Ransford S. McCourt, PE, PTOE
6528 SW Alden Street
Portland, OR 97223

May 10, 2021

Subject: Comments on Notice of Proposed Amendment (NPA) for the 11th Edition of the MUTCD

Section 2C.13 (NPA Item #123): Speed Feedback Signs

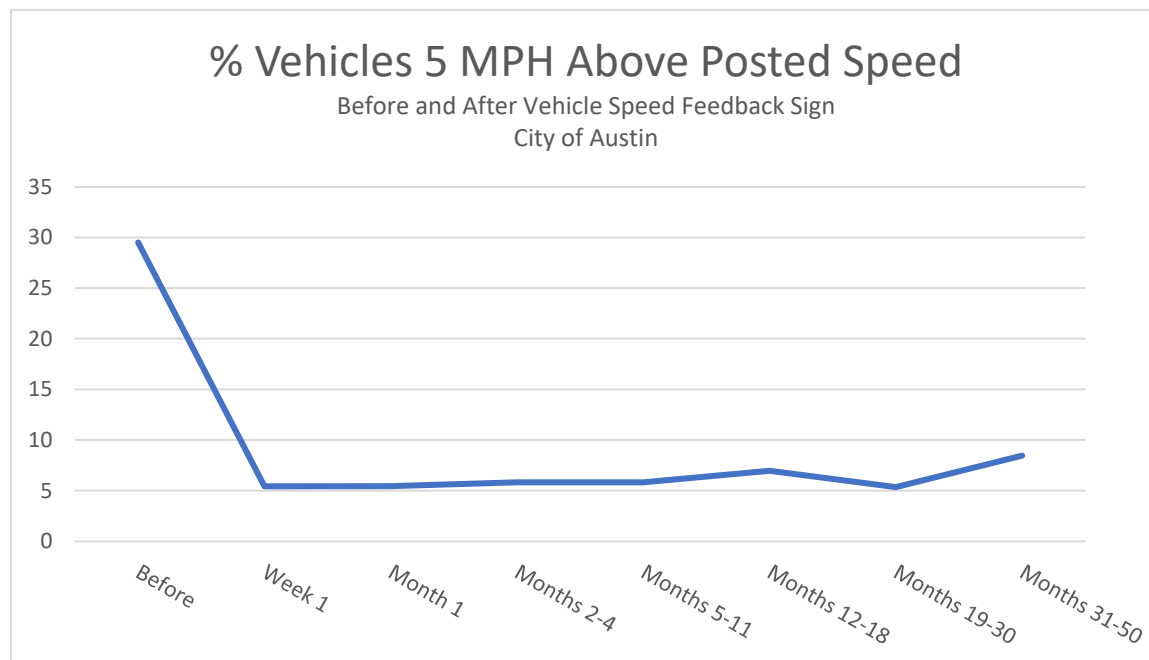
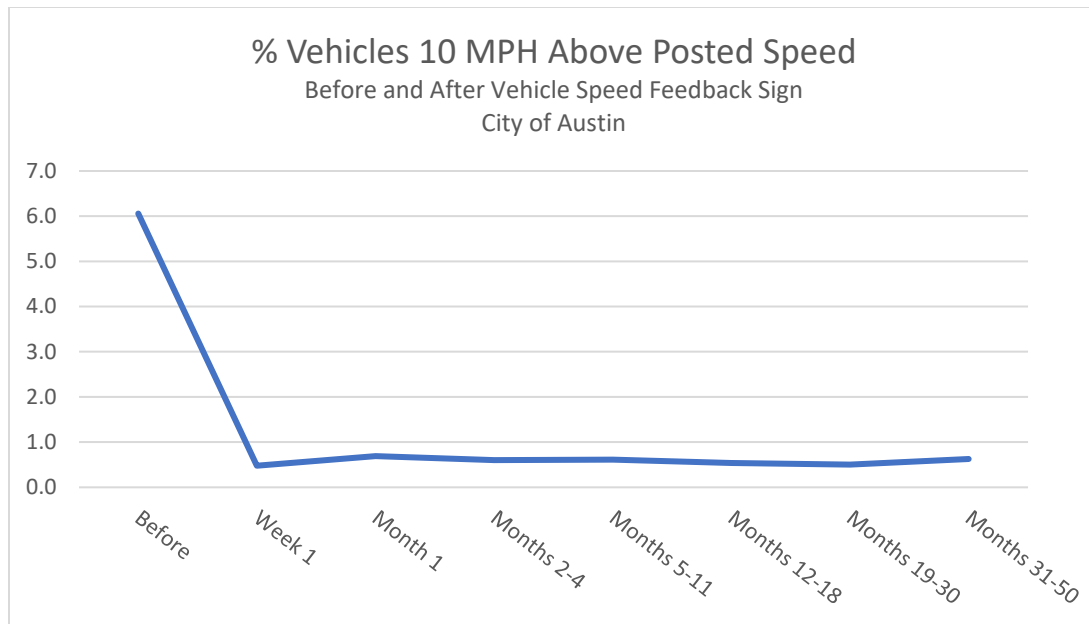
I want to thank FHWA for providing broader interpretation of speed feedback signs (W13-20 and W13-20aP) in a new Section 2C.13. Agencies have had extensive experience with these signs in the last decade and greater uniformity and guidance are appropriate at this time. However, the NPA still retains narrow guidance and restrictive standards that limit the benefits of this device from proven safety applications. Specifically, language that limits (or implies limits of) applications of the W13-20 to only horizontal curve warning or limits the use of the W13-20aP plaque only to speed limit sign applications

devalues opportunities to apply this device with proven safety benefits. I highly encourage the consideration and acceptance of the NCUTCD docket comments to Section 2C.13.

For example, the provision that allows fixed mounted W13-20 to be utilized on residential/neighborhood/local streets as well as portable applications (designed to the specifications FHWA has outlined in the NPA) have been demonstrated by numerous agencies to significantly reduce the percentage of vehicles traveling 5 and 10 mph above the posted speed (in the range of 60 to 70% reductions). These benefits should not be limited by NPA language that implies the only application is as a plaque below a speed limit sign.

In addition, I would advise FHWA permit more flexible use (with option language) of the W13-20aP toward it's proven safety benefit to horizontal curve warning (as demonstrated in research FHWA-HRT-14-020 Evaluation of Dynamic Speed Feedback Signs on Curves: A National Demonstration Project, January 2015). Greater use of this sign would be a significant safety countermeasure with the new 11th edition of the MUTCD to reduce run off the road fatalities and serious injuries at low cost. The research exposes the safety benefits of the flexible use of W13-20aP-type messaging to drivers (including DMS). For example, in addition to the NPA allowed free standing W13-20, use of the W13-20aP for horizontal alignment signs (particularly where space for a free-standing sign is difficult) with a W1-6, W1-8, W13-1sP and W13-2 to W13-13 should not be restricted in any way. Additionally, application in school zones can be effective supporting both the S5-1 with advance placement on a S1-1 or S4-5. The application of this device should remain flexible to allow designers to fit this device into complex field situations to the benefit of the traveling public. The current rigid language of the NPA will reduce potential safety benefit.

Stationary Radar Sign Program, City of Bellevue, 2009 (assessment of over 30 sites and 85th percentile speeds)

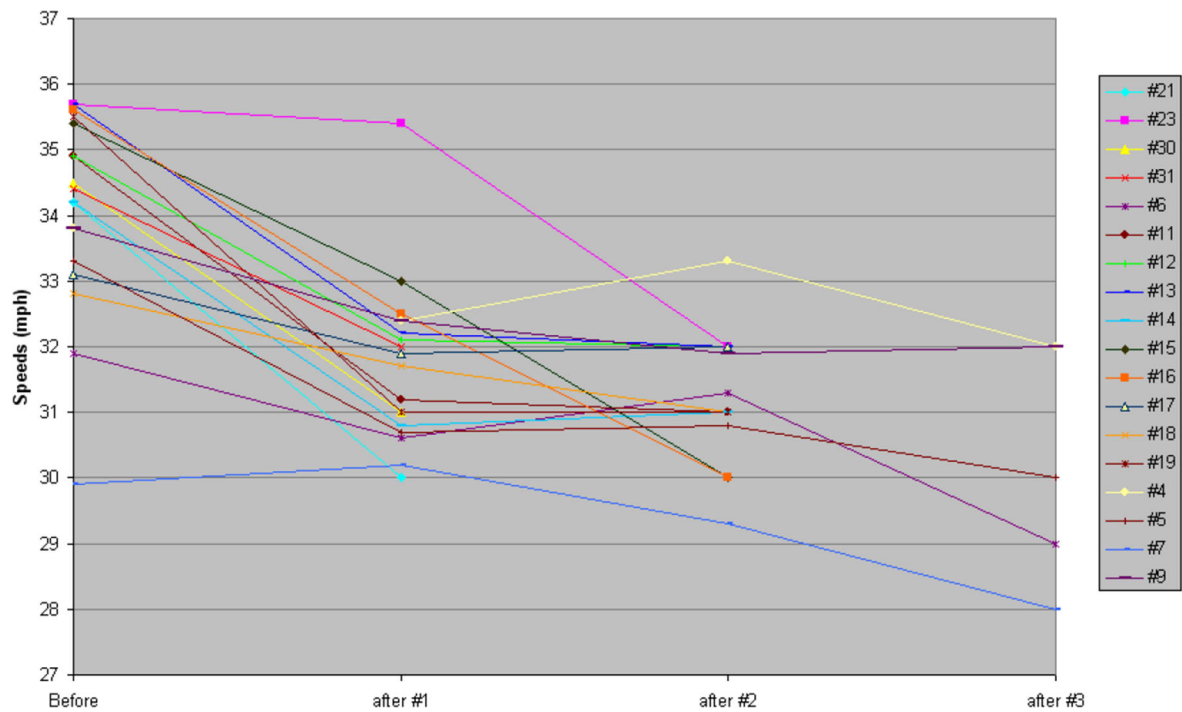
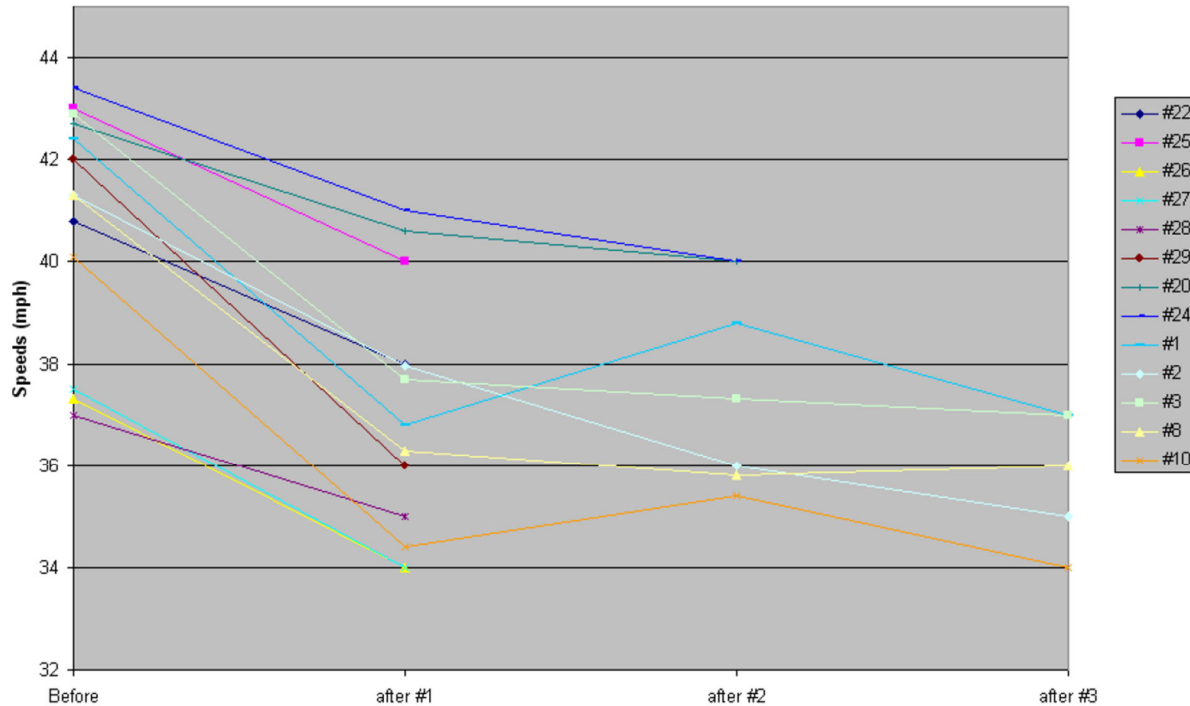
The speed reduction benefits are substantial. Research conducted by the City of Austin (TX) and Bellevue (WA) indicates large reductions in the highest speed vehicles and durable results over time with fixed position and plaque signs.

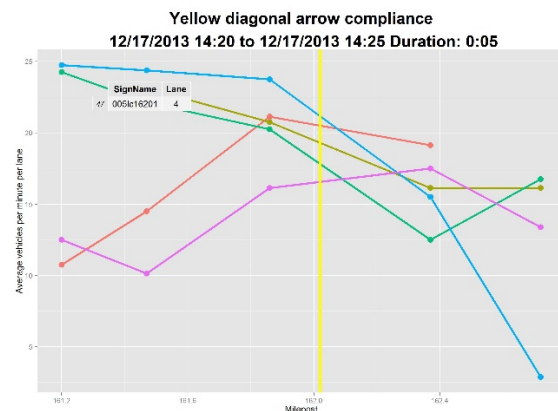
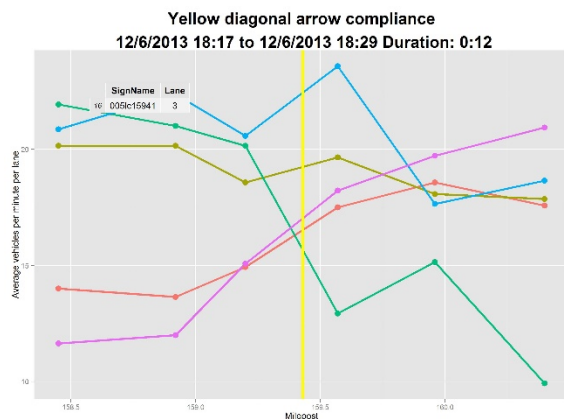
Having co-chaired the NCUTCD Task Force on Electronic Display, I would strongly support the NCUTCDs docket comments to this chapter. The NPA was published in December 2020 just as the task force was concluding its work and gaining NCUTCD approval at its January 2021 meeting (incorporated by reference as NCUTCD Council item 20B-RW-03, approved January 20, 2021, attached – note changes are to the 2009 MUTCD in this document). Given the limited time to review NPA changes, the ability to rationalize all changes recommended in 20B-RW-03 approval in the NCUTCD docket comments was not possible, therefore the full work is provided to FHWA for consideration. I specifically wish to reinforce the NCUTCD docket comments related to definition of changeable message signs (Section 1C.02). A NCUTCD CAV Joint Task Force sub working group has reached out to both NEMA and ITE related to these definitions to seek consistency in definitions for both NEMA TS-04 (2021 which is under draft development) and NTCIP 1203 v.03. This includes CMS as the umbrella term with DMS, hybrid, blank-out and line matrix as various examples of CMS. There are subtle differences between the three documents and I would recommend FHWA work to seek reconciliation between all three documents (MUTCD, TS-4 and 1203) building upon the framework established by the NCUTCD.

Because some of the recommendations of 20B-RW-03 are included in the NCUTCD docket comments, I want to focus on just five aspects that time limited the ability to advance specific recommendations that I believe would enhance the final rule:
